CII MODULAR ELECTRICAL IN PATIENT CARE AREAS

2. THE CII SOLUTION

INITIAL DESIGN – GROUND STRAP WIRE

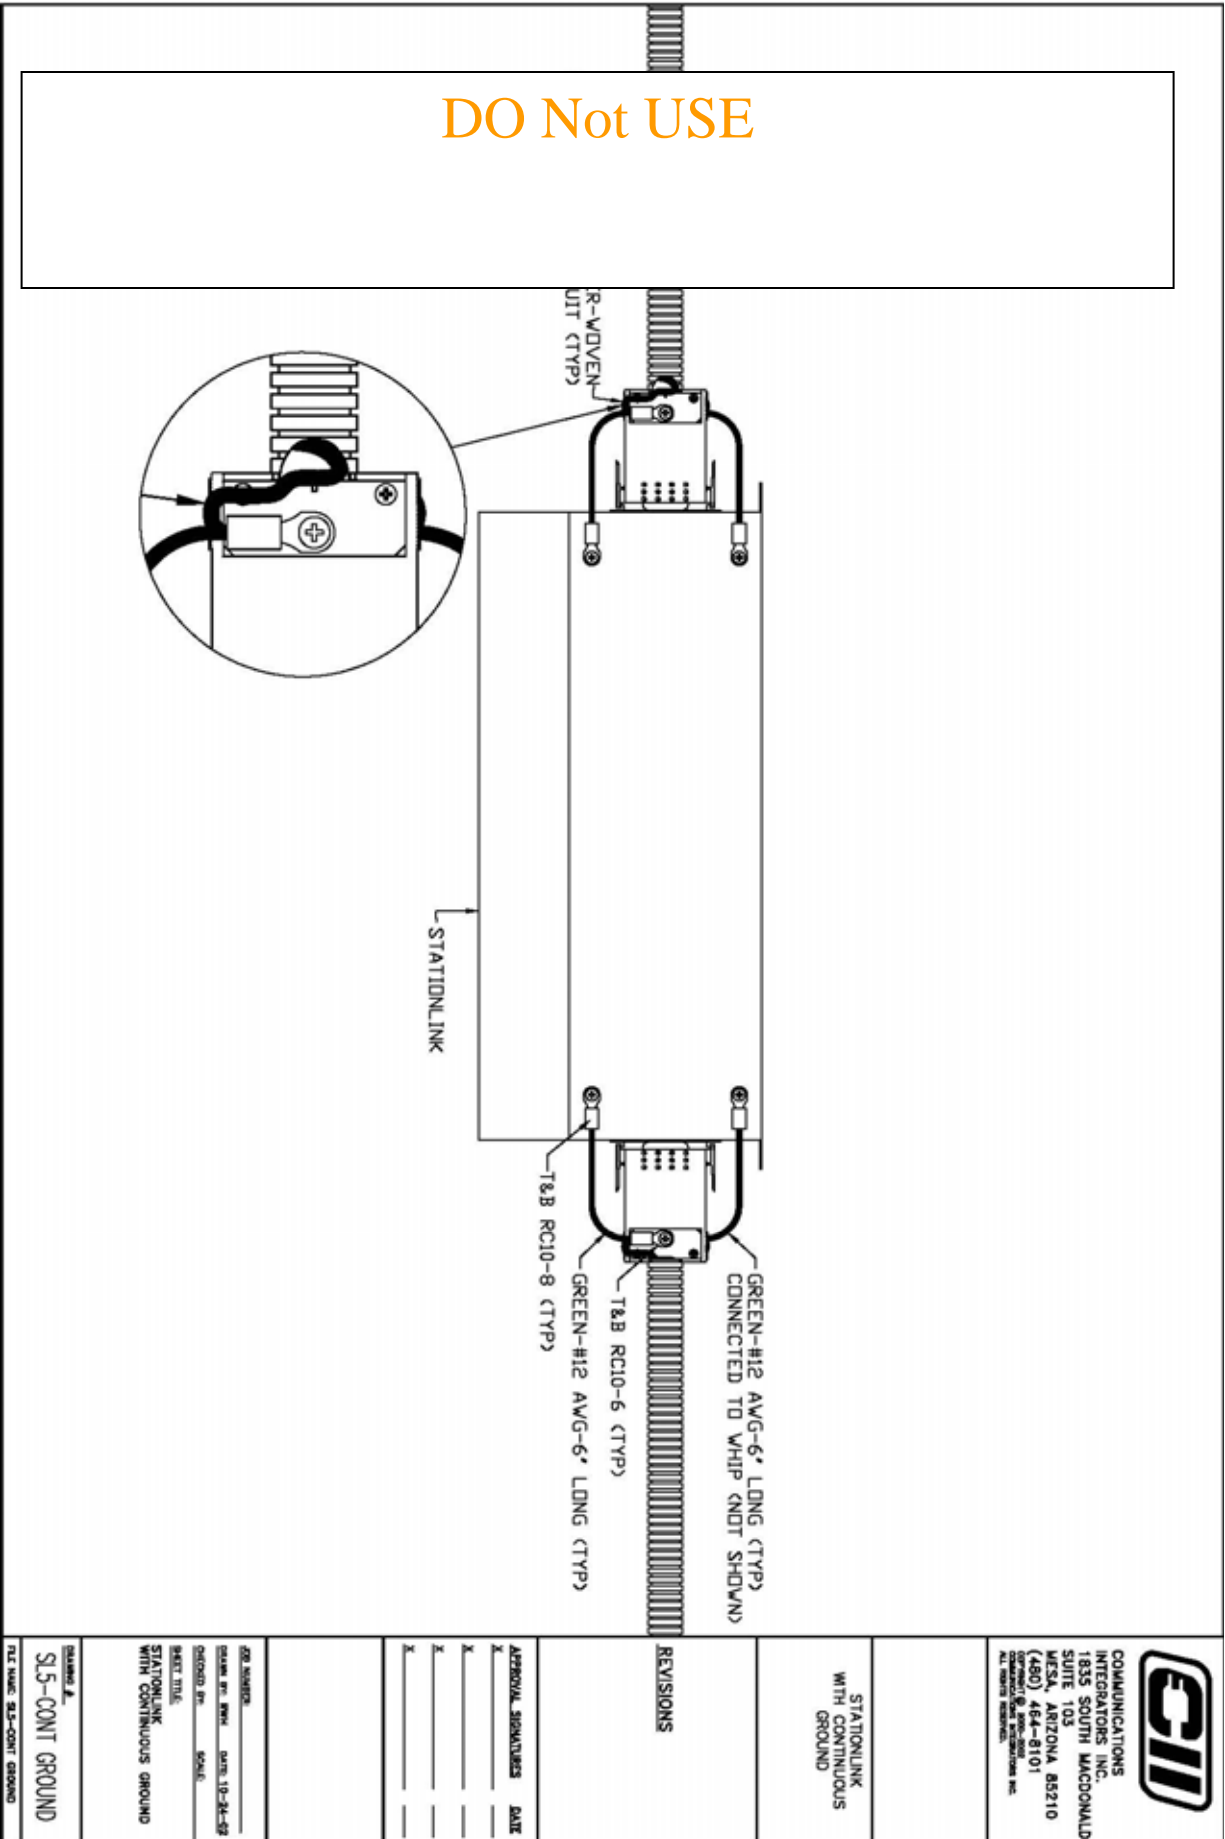
The final configuration we therefore submitted to UL for certification was a modular, five conductor, Type AC based cable, fitted with our standard 10-pin connectors. In order to ensure an unbroken equipment grounding return path via the AC Cable armor when one or more of our plastic 10-pin connectors is encountered throughout a cabling scheme, we incorporated bonding jumpers from the Type AC Cable armor, around the nonconductive plastic housing of our 10-pin connector, to the metal housing of the connected Power Distribution Module, Conversion Module, or StationLink device. (See Attached Drawing.)

Of all the Council members contacted, there were only four "non-positive" responses. Two of these non-positives were due to not fully understanding the concepts involved. Once clarified by the UL engineering staff, these two non-positives became positive responses. Of the two remaining non-positives, one did not want to trust the integrity of our entire system to a wire jumper shunting, or bypassing the plastic connectors of our whip heads; A chain is only as strong as its weakest link. This council member suggested we replace the jumper wire with a steel clam shell type design. The last non-positive response was from a

After final review of all council members' feedback, UL determined that they would list our system for use in Patient Care Areas, provided that we change the wire bypass/jumper to the clam shell design suggested in the Executive Council feedback. We have submitted drawings to UL showing the clam shell design we intend to use to replace the wire jumper, (see attached drawing). UL has approved the concept drawing and says that if thus submitted there should be no problem in the performance they are expecting from the clam shell whip head bypass.
